UNITED STATES PATENT AND TRADEMARK OFFICE

Office Action Summary

10/785,196

RANDAZZO, JOSEPH J.

Fig. 3

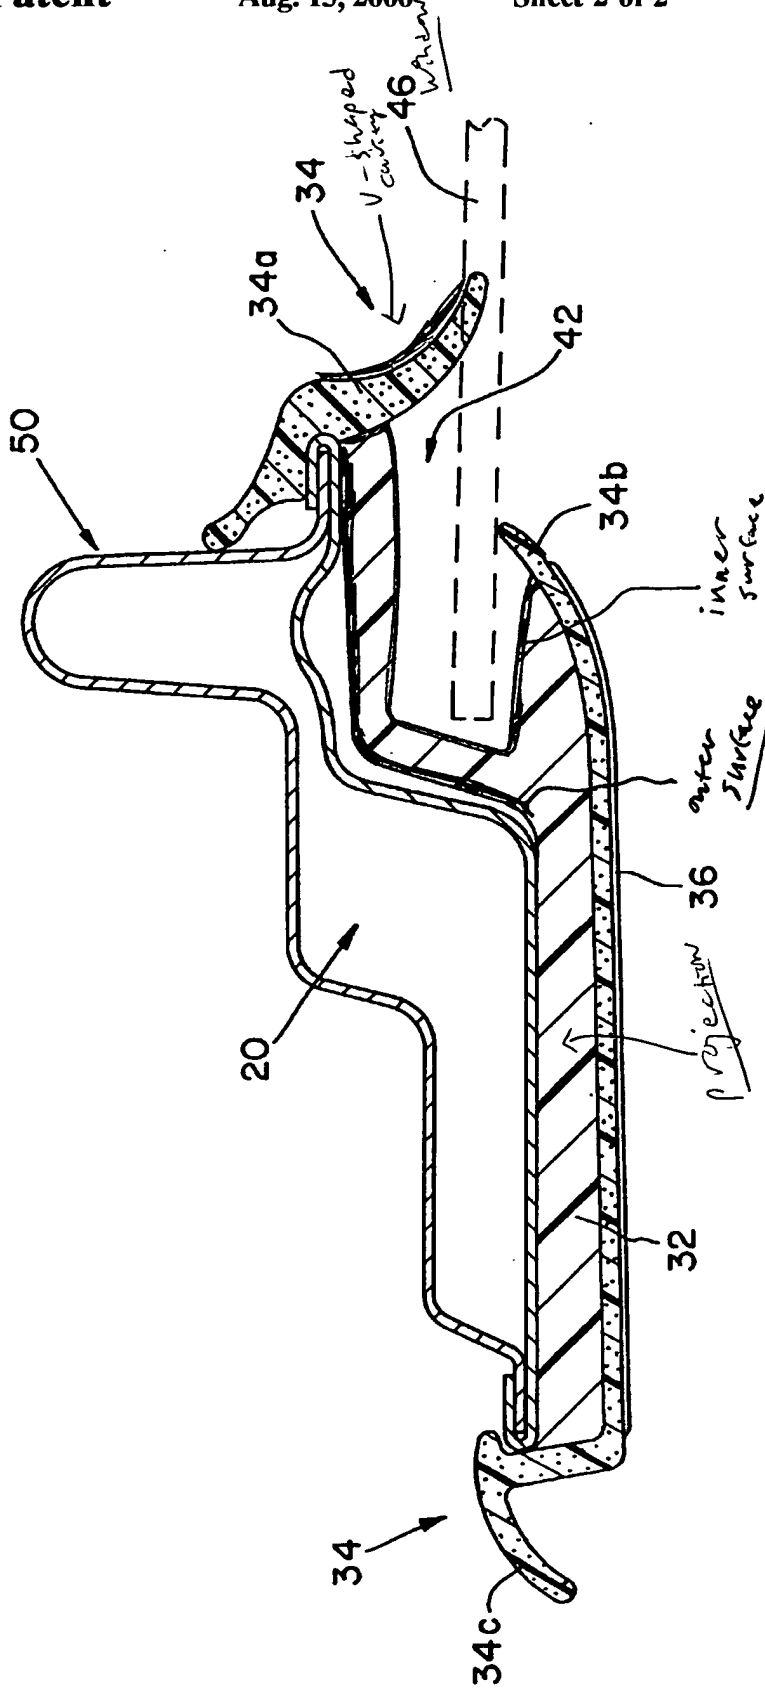
For claim 9, Kelly (6,103,168) discloses applique for use at a pillar area of a vehicle (Figure 1), the applique comprising: a polymer inclusive substrate 32, the polymer inclusive substrate including an interior surface to be closest to a vehicle window and an exterior surface to be further from the window than is the interior surface (Figure 3); a polymer inclusive flexible thermoplastic elastomer portion 34 including at least one flexible lip or leg for engaging a surface or edge of the vehicle window 46, wherein said substrate and said thermoplastic elastomer portion are “bonded” at least on part of said interior surface of the substrate which is to be closest to the vehicle window (Column 4, lines 31-38); wherein said thermoplastic elastomer portion and said substrate are of different materials having different hardness values which are selected so that the thermoplastic elastomer portion and the substrate are molded or bonded to one another without a separate adhesive layer therebetween, and the thermoplastic elastomer portion is more flexible than the substrate; and wherein said substrate includes a projection (Figure 3) extending from the exterior surface of the substrate 32, said projection being approximately perpendicular to a base portion of the substrate, and wherein said projection extending from the substrate does not contact said thermoplastic elastomer portion that includes the lip or leg that is for engaging the surface or edge of the vehicle window (see marked-up copy of Figure 3, hereto attached).

With regard to claim 12, the thermoplastic elastomer portion 34 at least partially defines a cavity, wherein one side of the cavity is defined by a first portion of the thermoplastic elastomer portion and another side of said cavity is defined by a portion of the thermoplastic elastomer portion that is to engage the window (see marked-up copy of Figure 3, hereto attached).
